# **Attachment C**

<h2><b>Engagement Report</b></h2>
-----------------------------------

# Engagement Report – Wellington Street cycleway

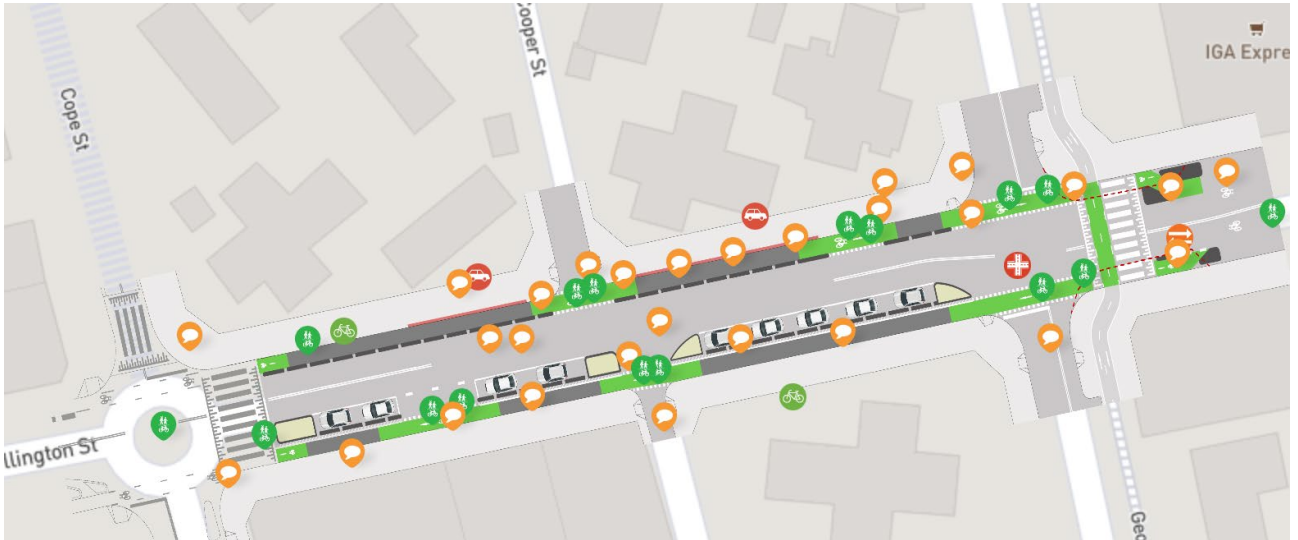
Comment	CoS Response	Count	Up	Down
<b>Continue the connection to the east</b>	The cycleway extension to the east of George St is not part of this project scope, however, will be addressed in future.	3	31	3
<b>Support the barrier separating bikes from traffic at the eastern end</b>	Noted.	1	4	1
<b>Mitigate parking loss</b>	There is ample off-street parking for residents of this section of Wellington Street, as well as for residents nearby. Parking management can be applied to address availability of on-street parking if necessary.	1	0	9
<b>Doesn't support the one way, two lane cycleway arrangement due to dooring danger</b>	The cycleway and the buffer between car doors and the cycleway will be wide enough to mitigate this concern.	3	1	2
<b>Simplify the transition from the George Street cycleway onto Raglan Street</b>	Changes to the George St cycleway near Raglan St are not part of this project scope.	3	7	0

<b>Simplify the transition from the George Street cycleway onto Phillip Street</b>	Changes to the George St cycleway near Phillip St are not part of this project scope.	1	2	0
<b>Connect the shared path on Buckland Street to the east</b>	The connection between the shared path on Buckland St and the new cycleway network is part of the Sydney Metro works that is separate to this project scope.	1	2	0
<b>Upgrade roundabout on Cope Street to prioritise bike safety</b>	The existing roundabout at Cope St and Wellington Street will be replaced with a raised pedestrian crossings as part of the Sydney Metro works that is separate to this project scope.	2	2	0
<b>Contraflow cycleway on Buckland Street is too narrow and overhung by parked cars</b>	Changes to the existing cycleway on Buckland St are not part of this project scope.	1	0	0
<b>Install additional signage at intersections</b>	Noted. The design will consider signage at the intersections	1	2	4

<b>Use a design speed of 30km/h</b>	Noted.	1	0	0
<b>Smooth the transition treatments just east of George Street</b>	Noted, this will be addressed in the detailed design.	1	2	0
